STANDARDS & SPECIFICATIONS SITE INSPECTION REPORT LEVEL 1 (FIELD REPORT)

Project Name:	Mountain Valley Pipeline	S&S Program:	Mountain Valley Pipeline (SS027)
Inspector:	Marshall Willis	Inspection Date:	Thursday, July 31, 2025
Project Contact:	Cory Chalmers Brian Clauto	Project Contact Email:	cory.chalmers@eqt.com brian.clauto@eqt.com
Spread I: Franklin County	STA 14250+00 – 14311+57 MVP-FR-313	Site Conditions:	Wet

Fig. 2

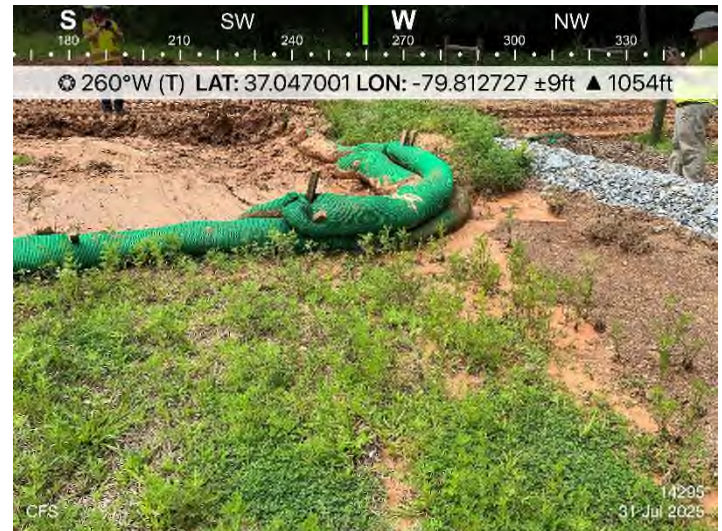
STA 14295+00: Repair undermined CFS.

Corrective Action: Maintain and install all controls per the approved S&S.

Deadline: Within 24-Hour of Notification
